HENDERSON COUNTY
Planning Department

TO: Henderson County Planning Board
FROM: Matt Card, Planner
DATE: January 12, 2007
**SUBJECT: Revised Combined Master Plan and Development Plan Review for The
Boulders at Stoney Mountain Major Subdivision (File # 07-M01)**

Staff has reviewed the submitted revised Combined Master Plan and Development Plan for The Boulders at Stoney Mountain for conformance with the Henderson County Subdivision Ordinance (HCSO) and offers the comments that follow.

Jasper Drive

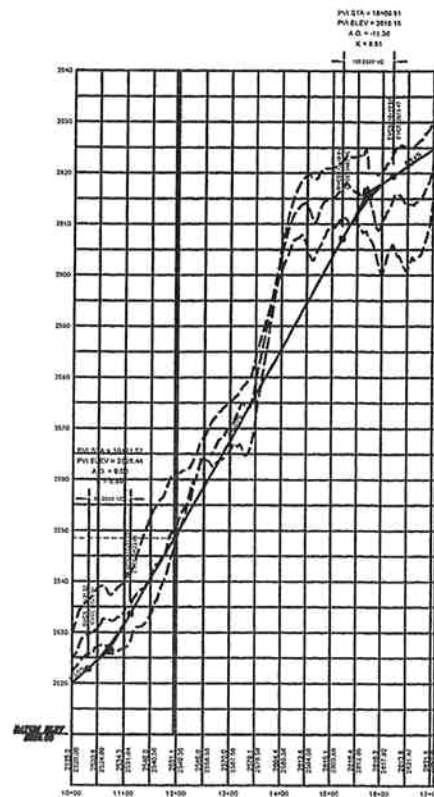
8. **Collector Road Standards.** The section of Jasper Drive along lot 24 must be built to collector road standards because it appears 25 lots are served by this section of Jasper Drive including lot 24.

RT1

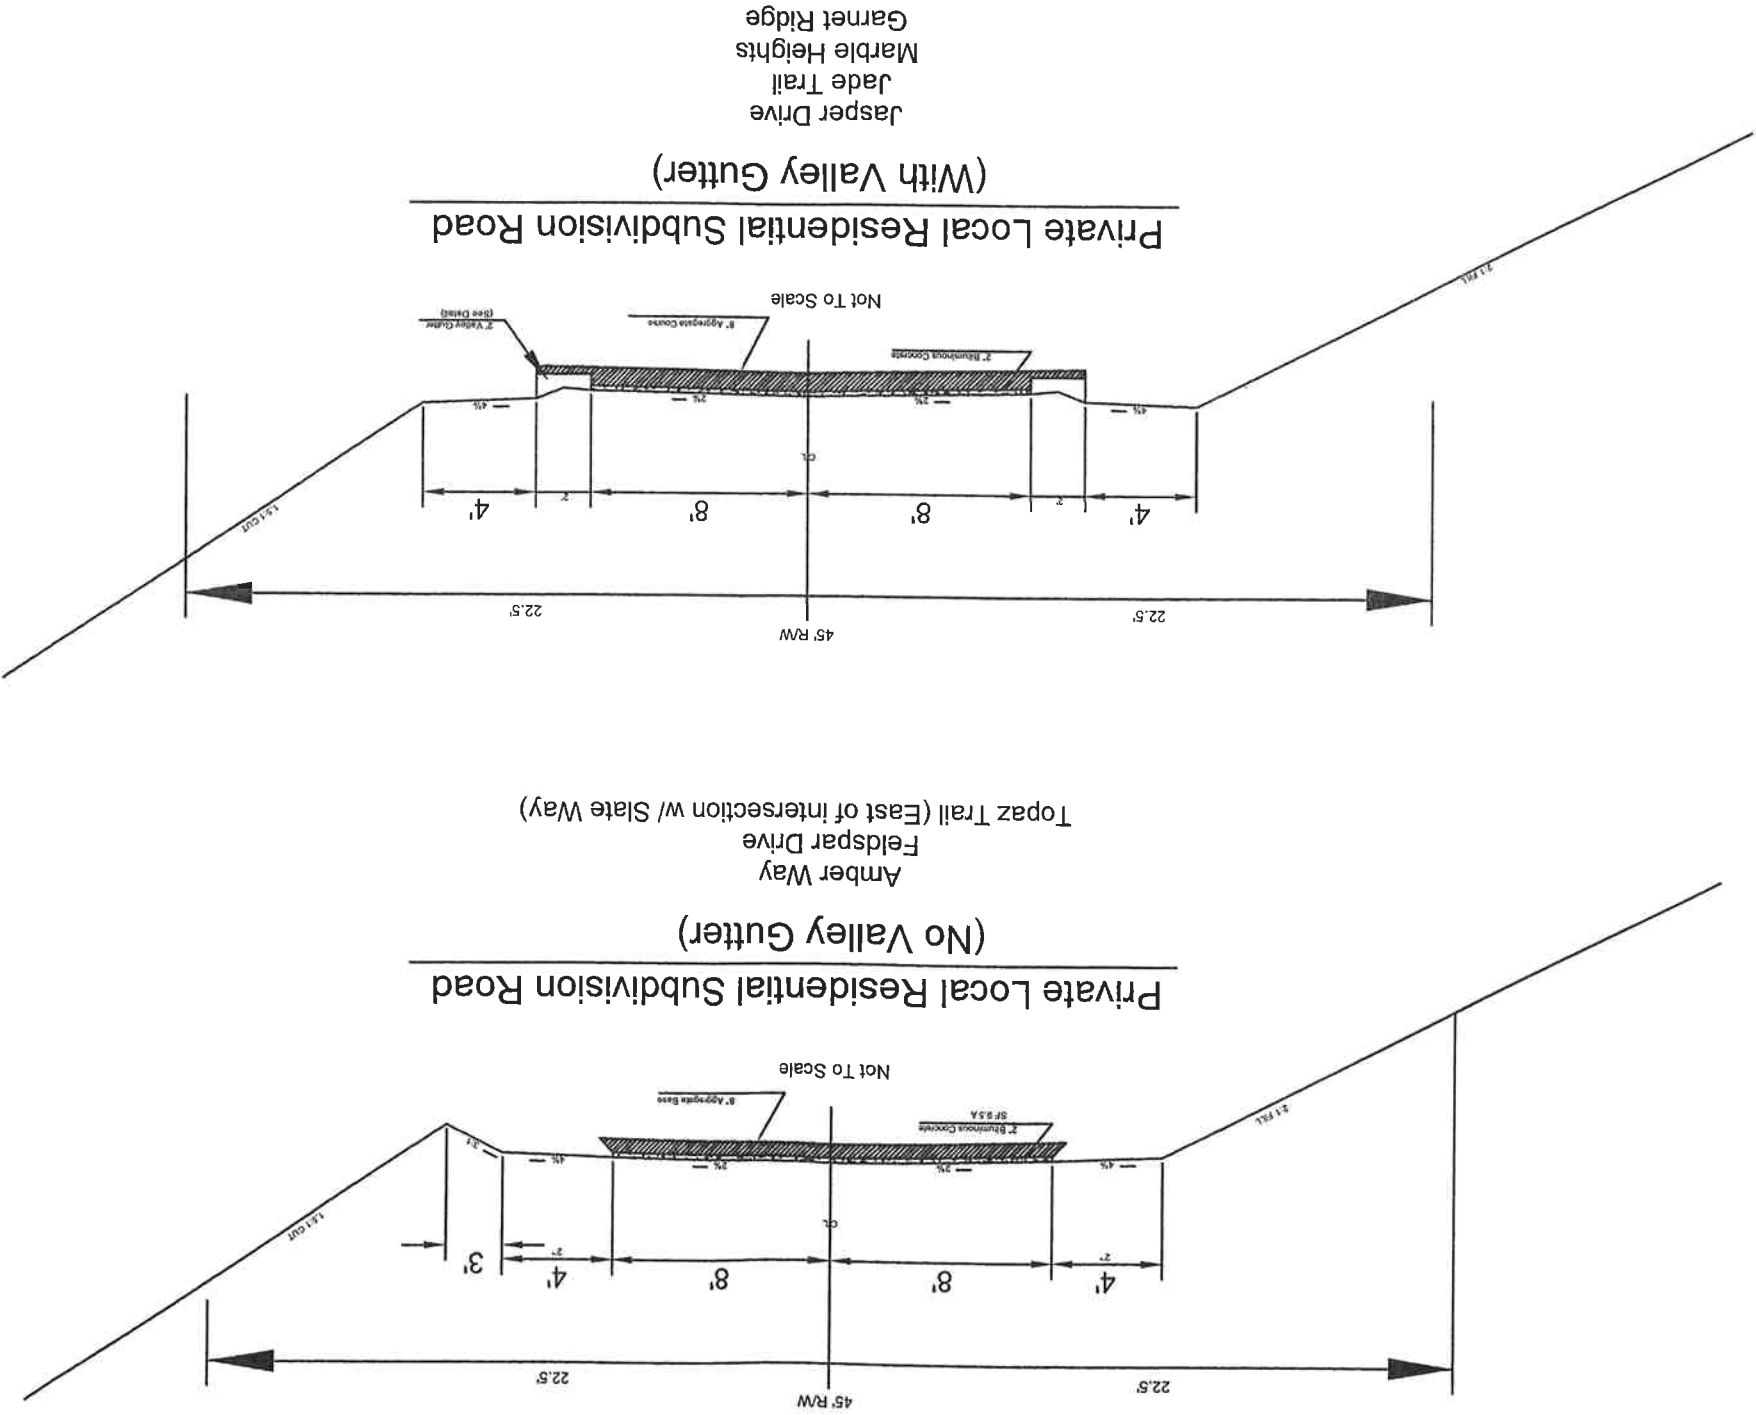
minimum centerline radius of 80 feet is permitted. It appears on the Plan that the applicant is requesting these reductions. The applicant is also requesting to reduce the shoulder widths in certain areas in accordance with Section 170-21, Table 1 of the HCSO. The Final Plat(s) must have a notation that states where the existing cross slope exceeds 15 percent a minimum centerline radius of 60 feet and 80 feet, respectively, are permitted (170-21F of the HCSO). The applicant should also provide a note on the final plat regarding the shoulder reduction.
